Service

Category Engine/Hybrid System

Section	Emission Control	Market USA	Lexus Supports ASE Certification
---------	------------------	------------	-------------------------------------

Some 2015 – 2019 model year Lexus vehicles equipped with the 8AR engine may exhibit a rocking (forward and back) sensation that can be felt between 30 and 70 mph under steady/high throttle input and/or a buzzing noise from the engine compartment. Follow the Repair Procedure in this bulletin to address this condition.

Figure 2. New No. 1 Vacuum Transmitting Hose Routing

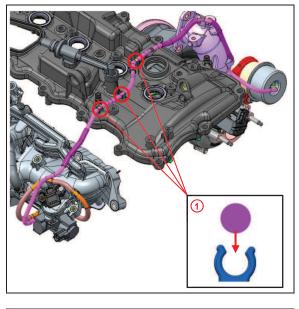
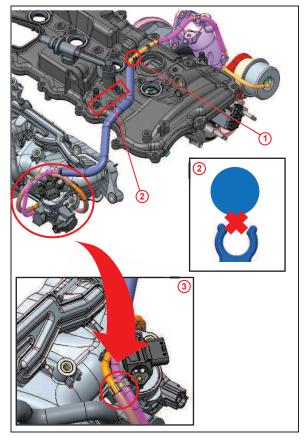
3. Replace the No. 1 vacuum transmitting hose with the NEW No. 1 vacuum transmitting hose. Follow the routing as shown in Figure 2.

Figure 1 shows the routing of the previous No. 1 vacuum transmitting hose.

No. 1 Vacuum Transmitting Hose Clamped to Cylinder Head Cover at Three Portions

1	No. 1 Vacuum Transmitting Hose Clamped to Cylinder Head Cover at One Portion
2	Cylinder Head Covers Incompatible With New No. 1 Vacuum Transmitting Hose
3	Additional Clamp Point (No. 1 Vacuum Transmitting Hose is Clamped to Other Hose by Using Hose Clamp)
